re: Darrow Residence
6242 Hazelwood Lane SE
Bellevue, WA
File No. 11-122838-LS
PKJB No. 10027

Thank you for your continued review of our project. I have read through your letter, dated April 19th, 2012, and offer the following response:

Darrow Residence Variance and Critical Areas Land Use Permit Application

File #s 11-122838-LS and 12-121725-LO

A1.1

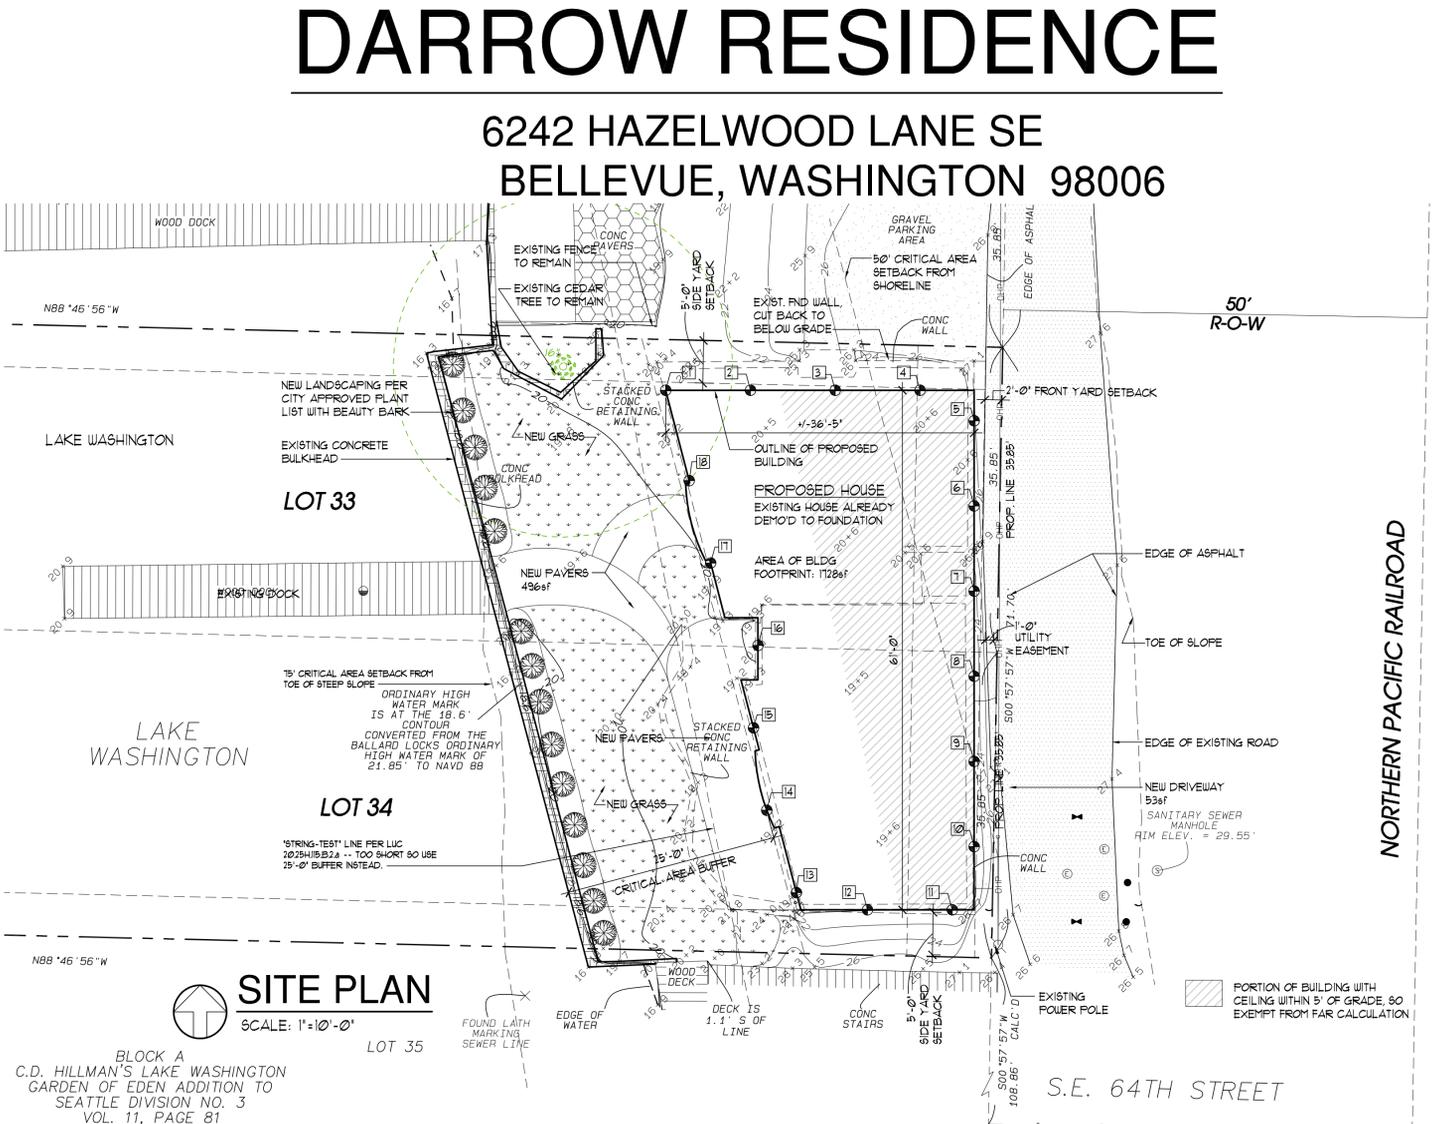
The maximum impervious surface area is 55%. The proposed impervious surface area is 2277 sq. ft., of which 496 sq. ft. will be pavers. This information has been added to sheet A1.1.
